ADDENDUM #1**1.1 PROJECT INFORMATION**

- A. Project Number: 2026-11230
- B. Project Title: BEB On-Route Charging Infrastructure
- C. Project Location: STA's Valley Transit Center at 10501 E 4th Ave, Spokane Valley, WA & Liberty Lake Park & Ride at 22501 E Mission Ave, Liberty Lake, WA
- D. Agency: Spokane Transit Authority

STA Route 9 BEB Charging Addendum #1 Narrative

E-601

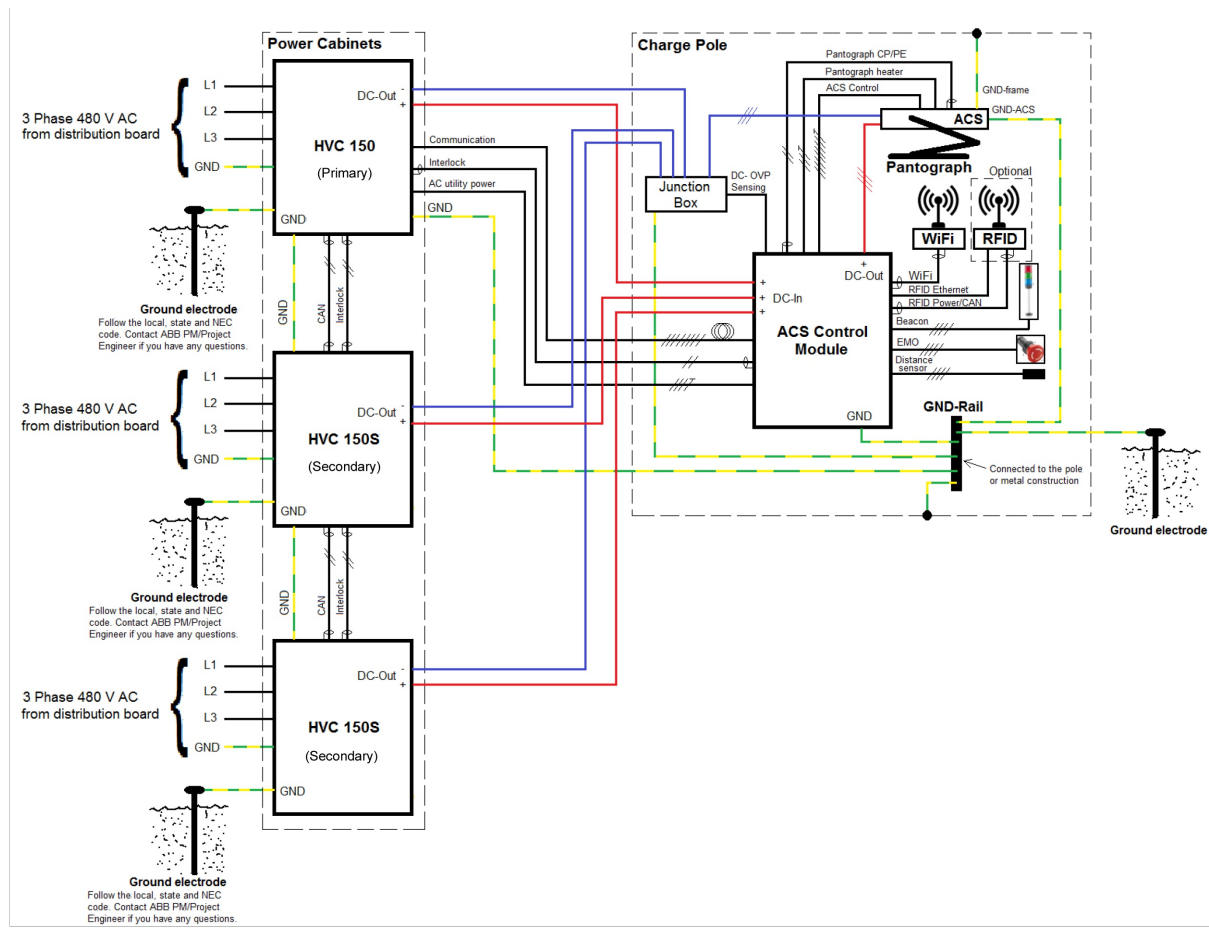
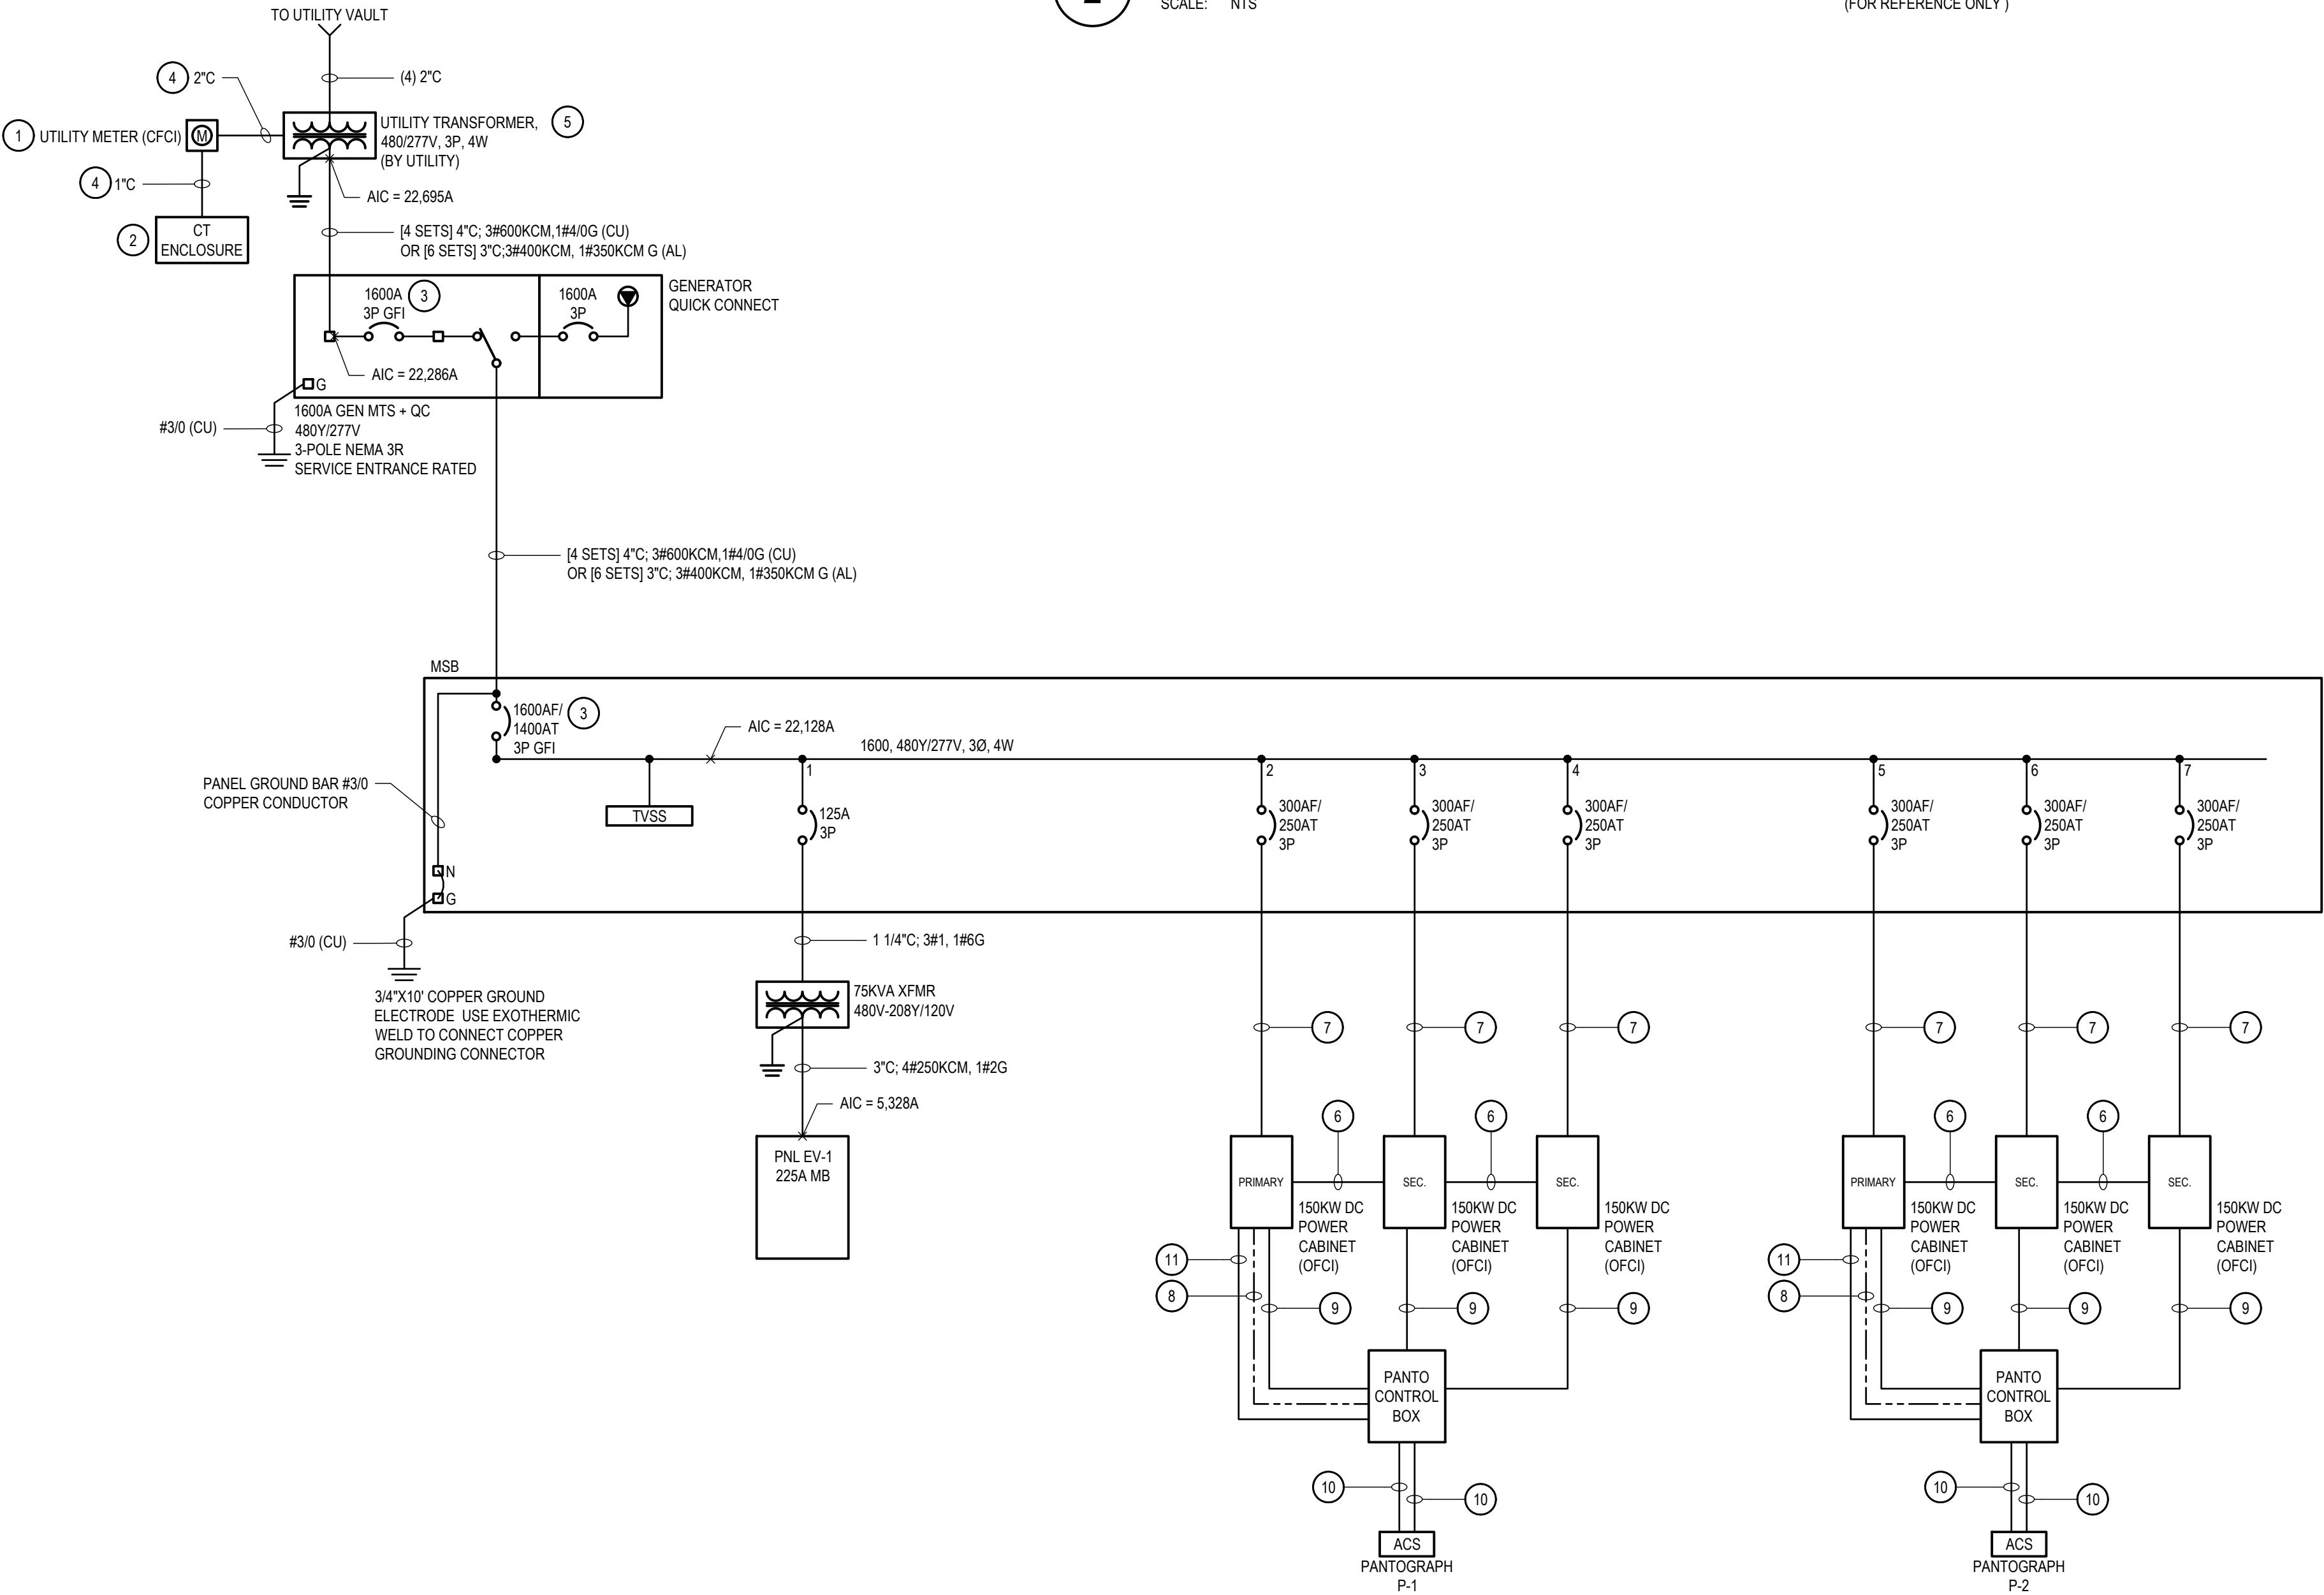
2. Revised: Equipment tag and added keyed note 4 to clarify labeling requirements.
- F. SHEET E-601 – ONE-LINE DIAGRAM
 1. Updated: Utility contact information for Malenie Cronk

OVERALL
STRUCTURAL
FOUNDATION
AND FRAMING
PLAN

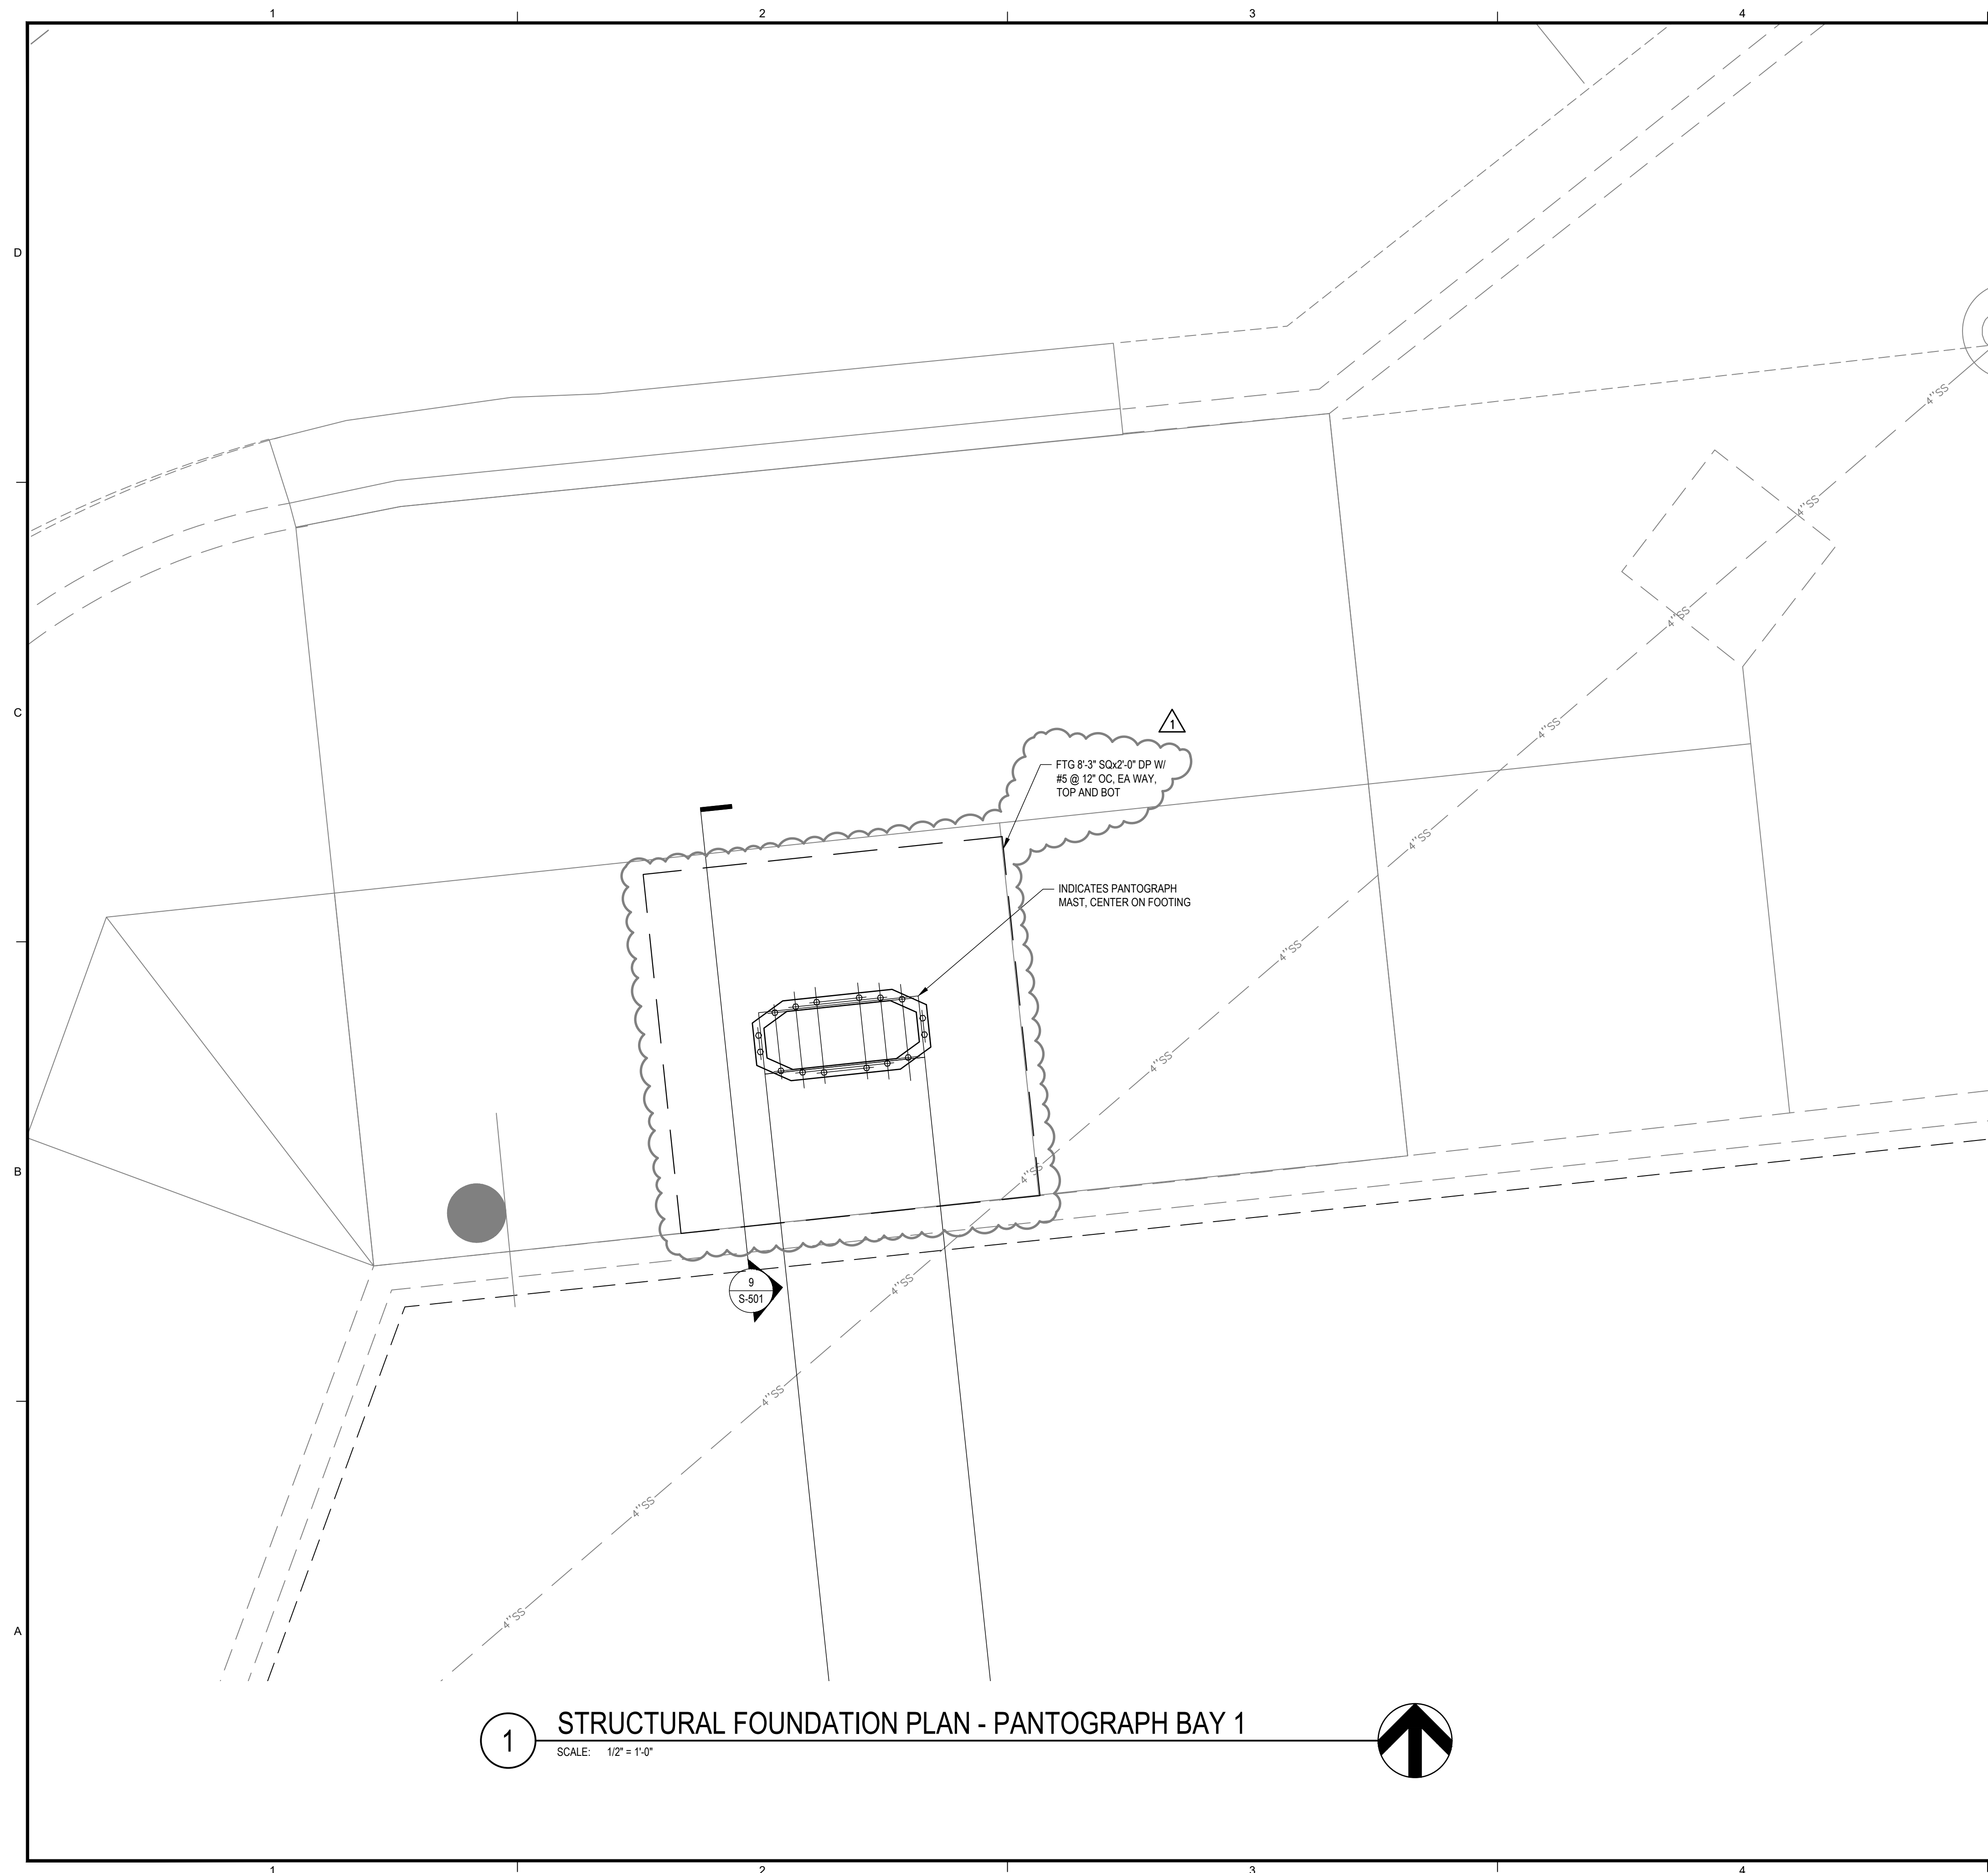
- H. SHEET S-100 – OVERALL STRUCTURAL FOUNDATION PLAN AND FRAMING PLAN
 1. Revised: Footing size from 7'-9" square to 8'-3" square.
- I. SHEET S-102 – STRUCTURAL FOUNDATION PLAN – PANTOGRAPH BAY 2
